RECEIPT DATE: 7/8/11 **ONSITE SEWAGE DISPOSAL SYSTEM**

PROPERTY ADDRESS: 15190 Bushy Park Road

RE: Septic Tank Cover – Safety Concern

RE: 15190 Bushy Park Rd
Waiver to Septic Setback

SEWER HOUSE CONNECTION

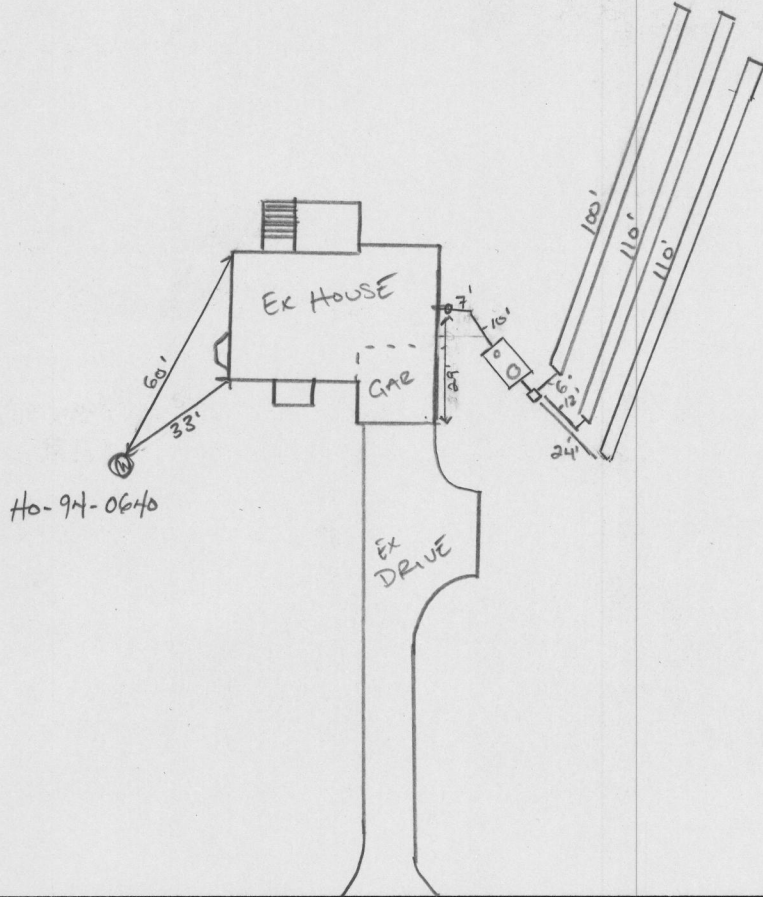
INSTALLATION: 9/19/2019 NEW SHC AND SEWER LINE INSTALLED TO TANK. NEW 3' RISER INSTALLED OVER INLET. EX BACK RISER HAS CONC LID. INFORMED BUILDER ON SITE (OUTLET RISER IS A SAFETY CONCERN), IT CAN BE EASILY URTED. SEND FOLLOW UP LETTER (P)

Please be advised that upon inspection of the sewer house connection into the existing septic system, the outlet tank riser was observed to be covered by an unsecured concrete lid.

Please be aware that this is a safety concern as anyone may be able to lift the concrete lid and enter or fall into the septic tank. The septic tank is a highly toxic and corrosive environment and exposure may result in organ failure and death.

The inlet riser has been outfitted by a secure septic tank lid. It is highly recommended that the lid of the outlet riser is upgraded to be secured such that the tank remains serviceable for regular pumping, but is not easily accessible, similarly to the inlet riser.

PERMIT PLAN
15190 BUSHY PARK ROAD
TAX MAP NO.: 8 GRID NO.: 21 PARCEL NO.: 383
ZONED RC-DEO
FIFTH ELECTION DISTRICT HOWARD COUNTY, MARYLAND
SCALE: AS SHOWN DATE: APRIL, 2019
SHEET 1 OF 1

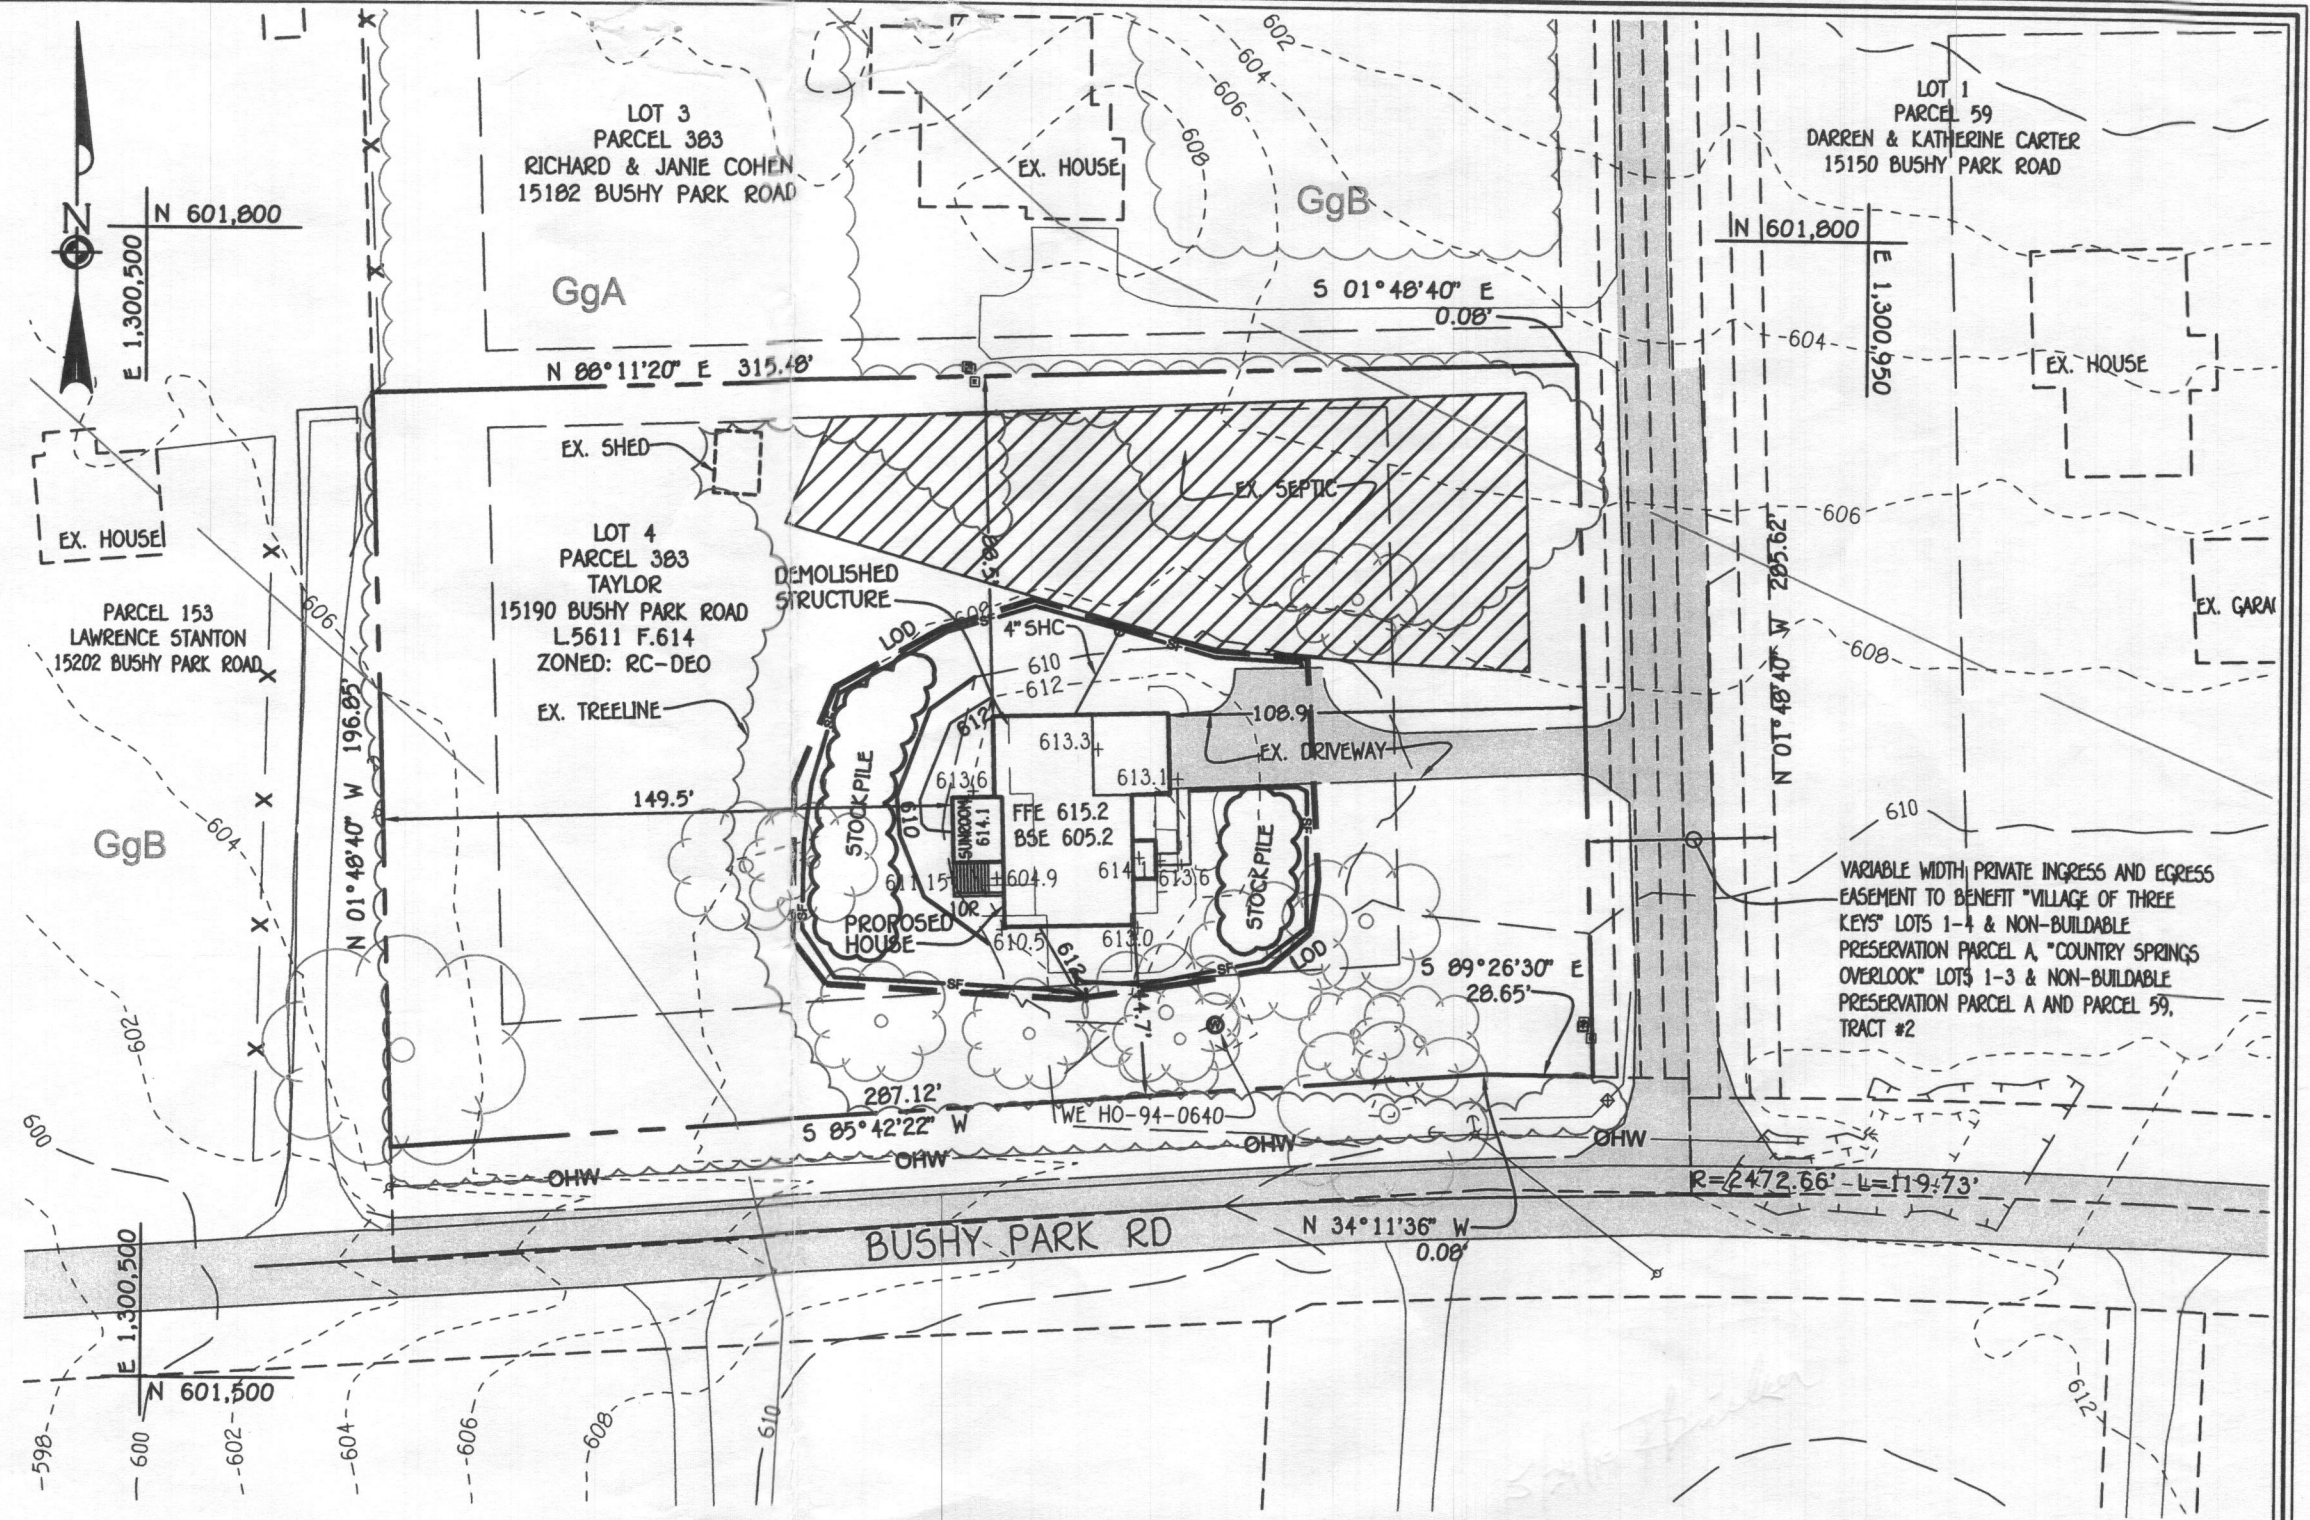
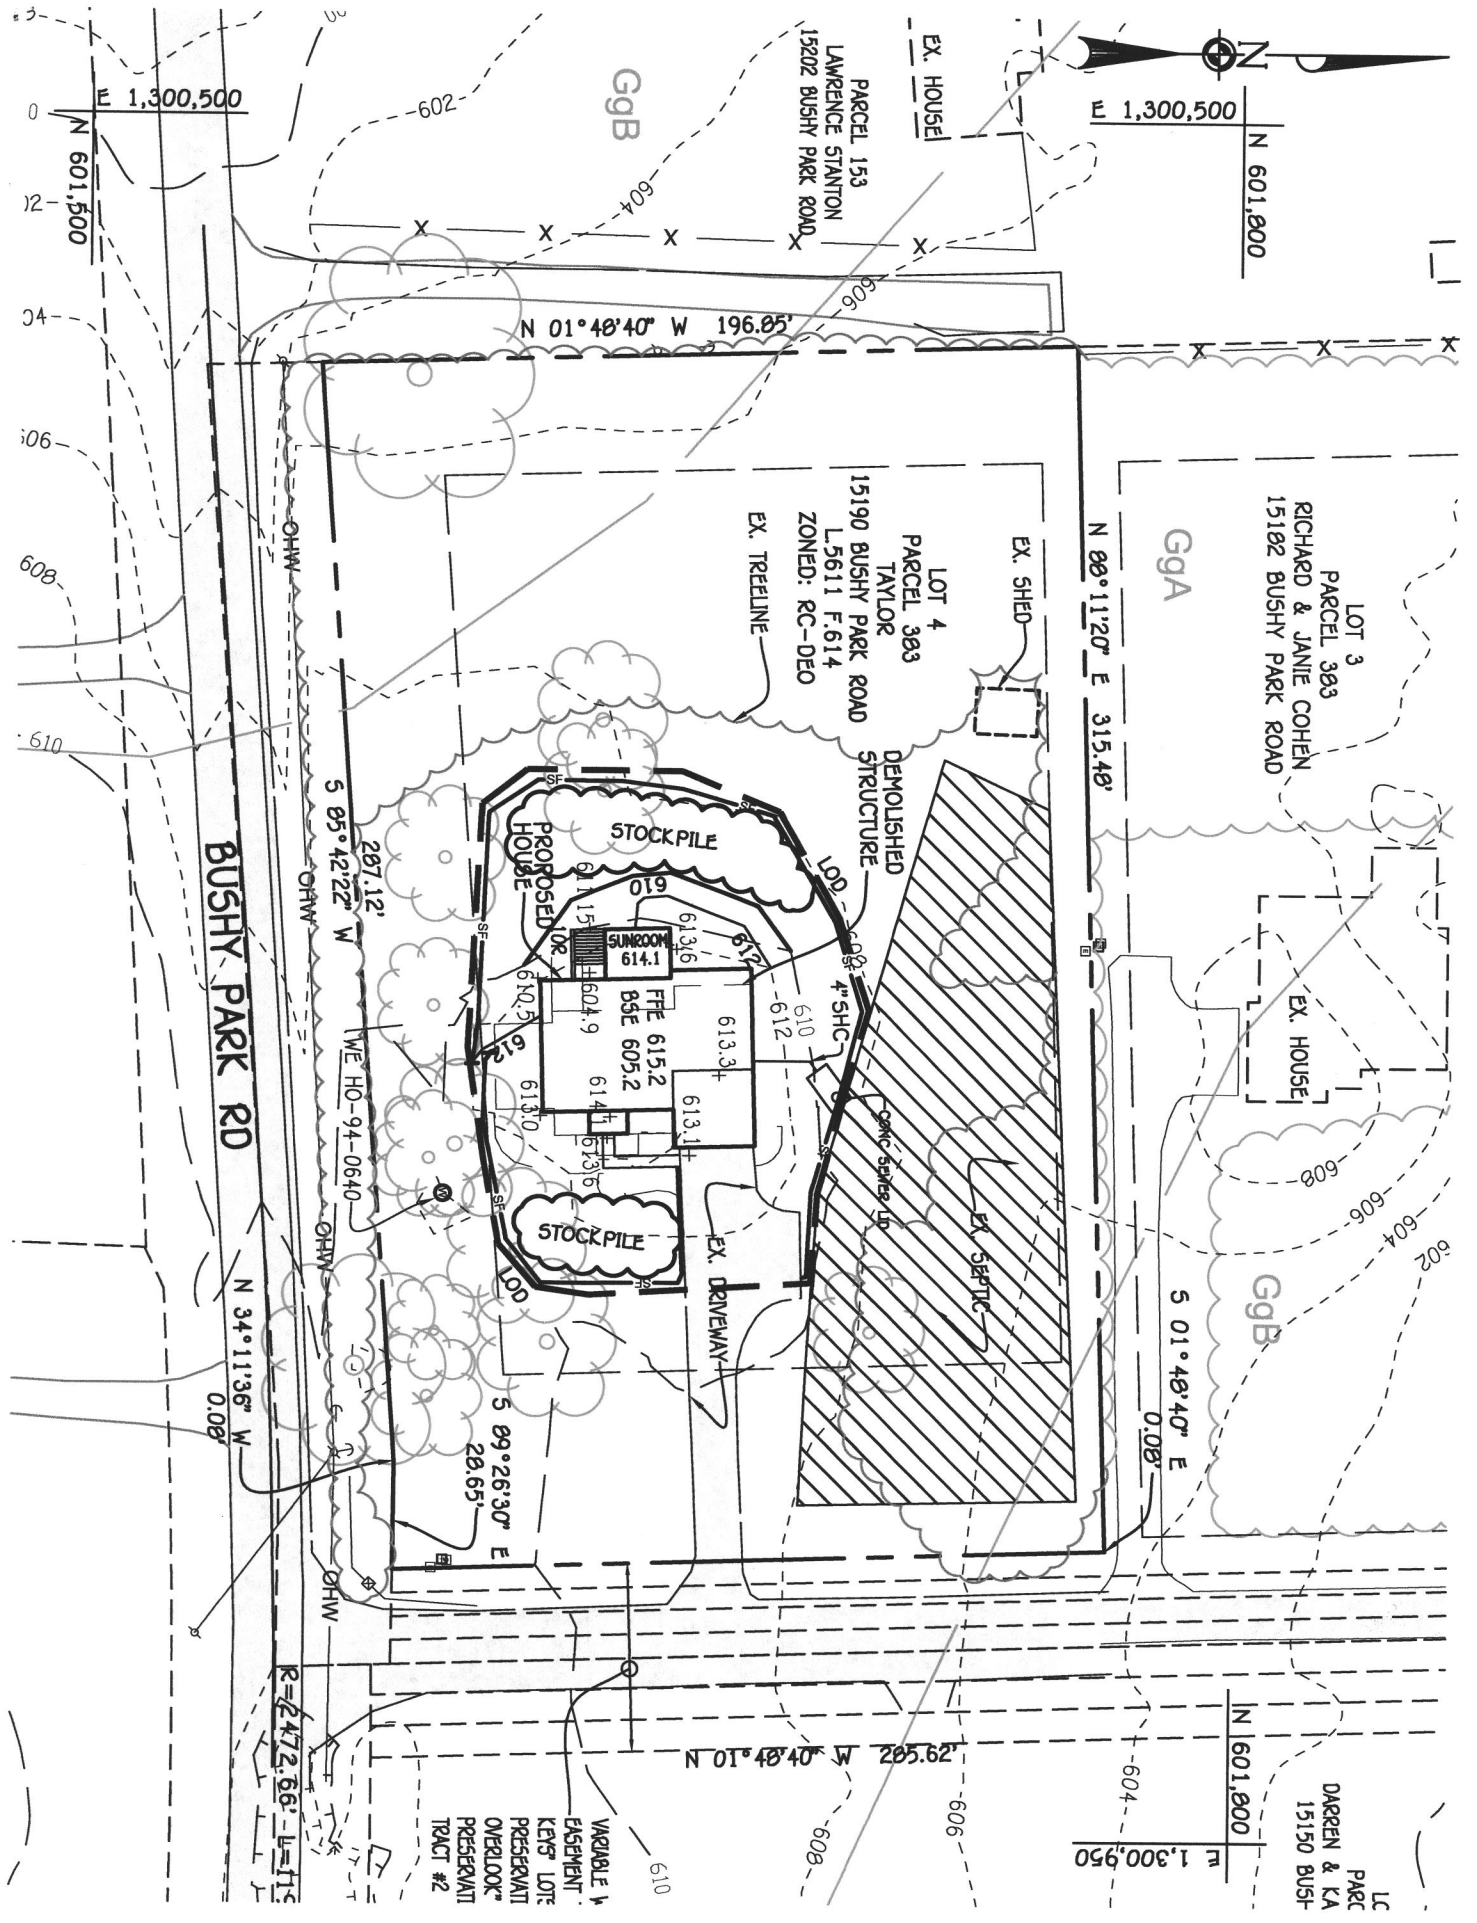
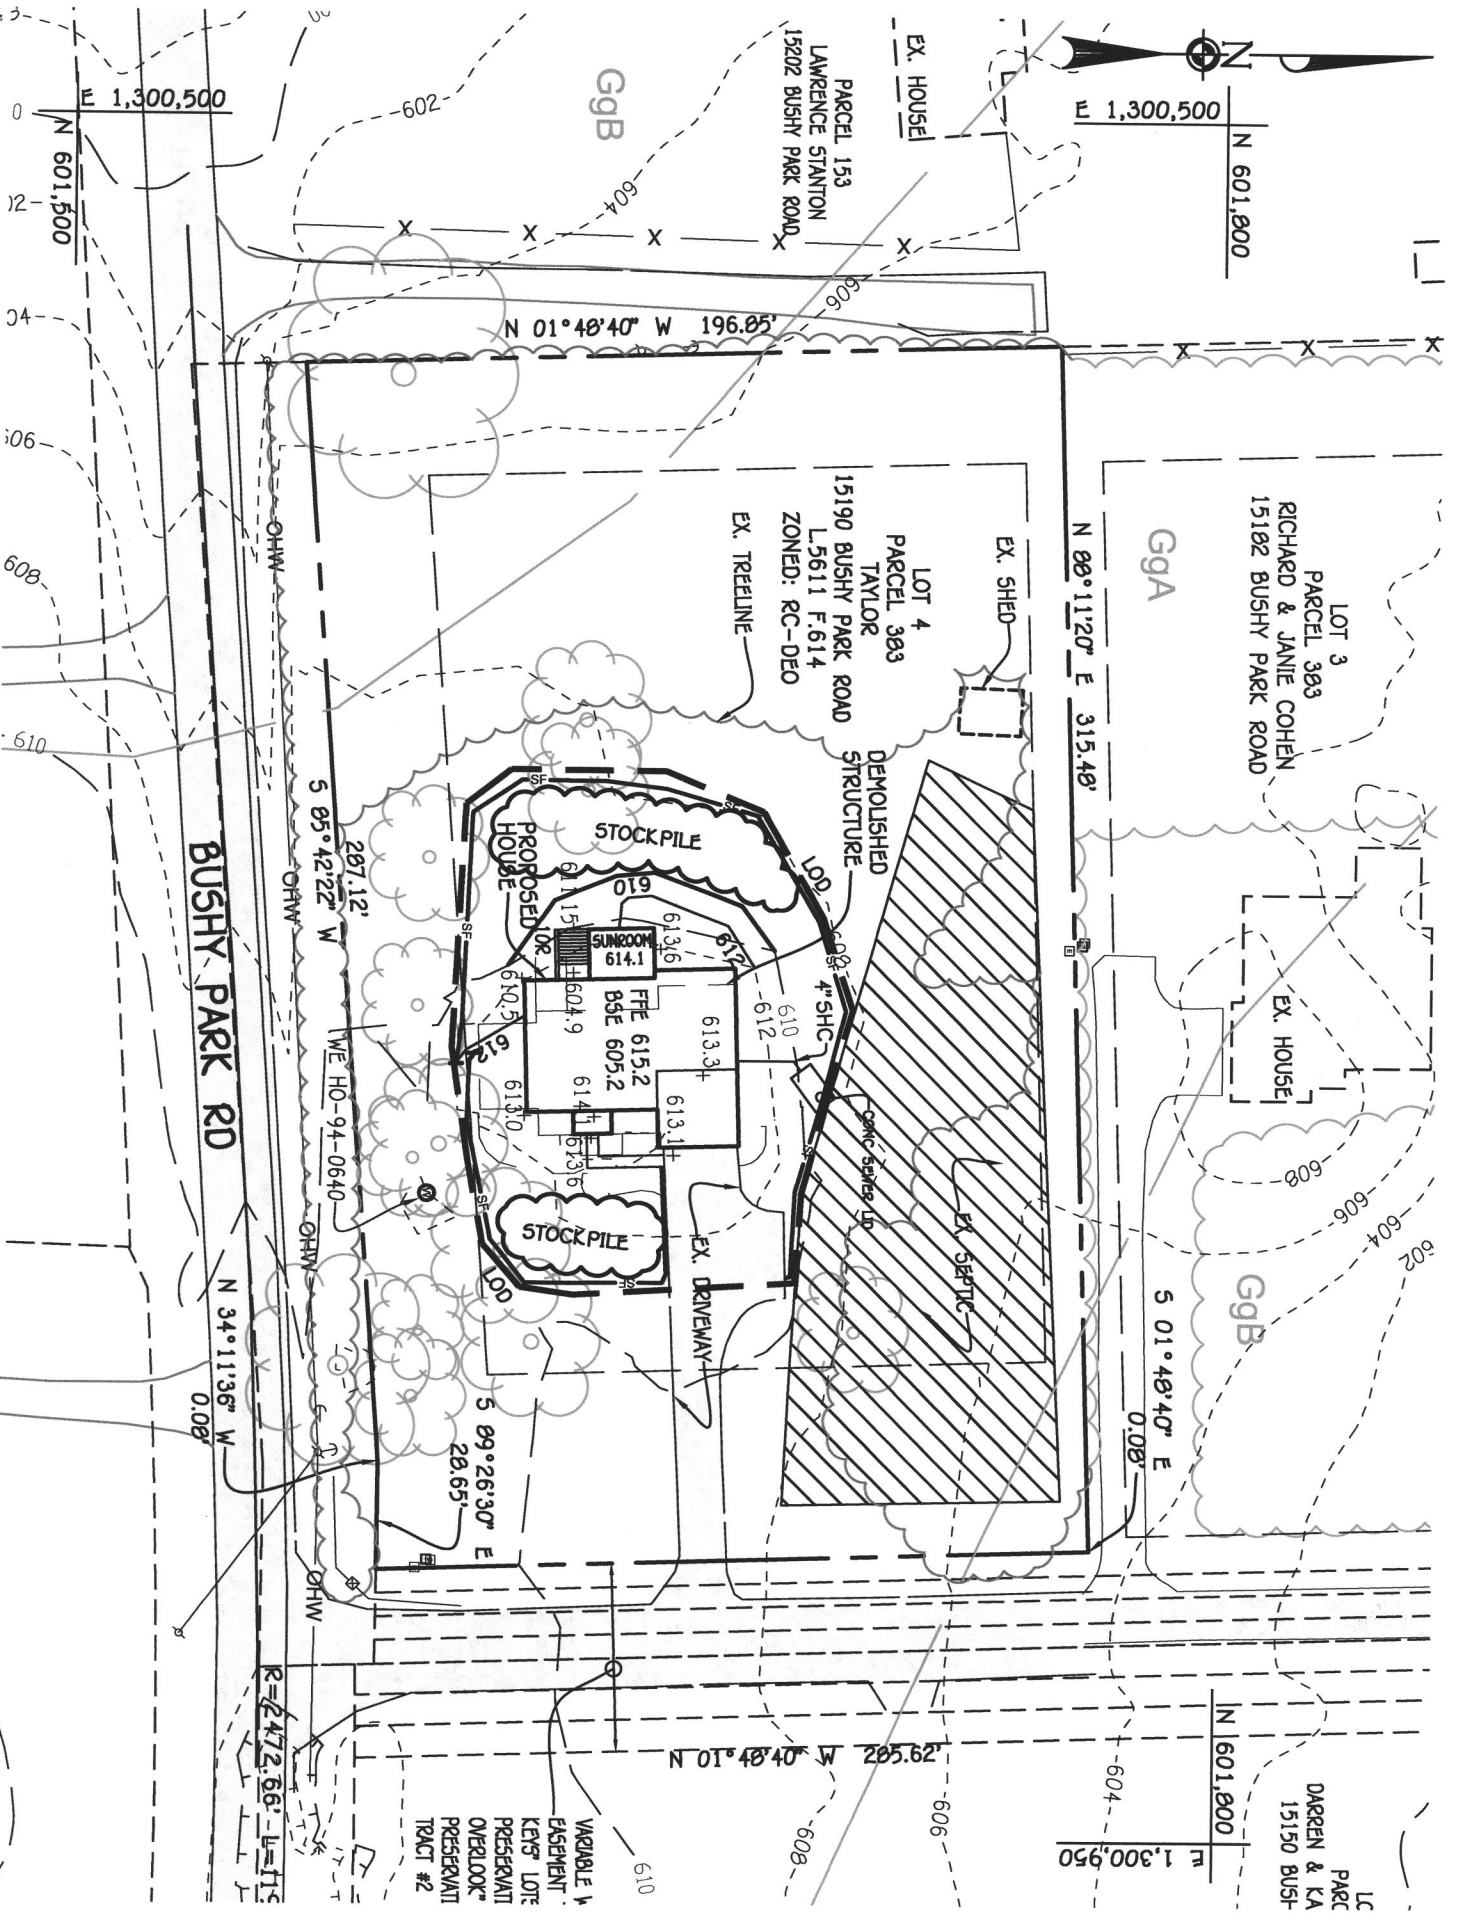
Good afternoon Tony. Mike is reviewing the waiver request submitted by Mr Taylor. Mr Taylor stated an "approximate" location for the septic tank. This presents a questionable situation as Mike has to declare a specific distance to which he is reducing the setback.

How was the septic tank location determined for placing it on the exhibit sent with the waiver request?

We hereby formally request a waiver to the twenty-foot setback between the proposed house and the septic tank. There are certain factors to consider when reviewing this request:

1. The proposed house is a rebuild and is being placed in same area as the original house that was built in 2001. The original house exploded due to propane leak caused by lightning strike and burning to the ground on 9/7/2018.
2. The center of the existing concrete lid to the septic tank is located approximately 22 feet from the proposed house. Although exact location of the tank is not known, the tank is located approximately 14 feet from the proposed house.
3. Attached is a sketch showing the approximate location of the septic tank relative to the proposed house to aide in your review of this request.

We talked about this one. I took the information from the installation notes, so it is not field located. The concrete access to the tank is field located.

5/24/19
Approved
Scott J. Iron
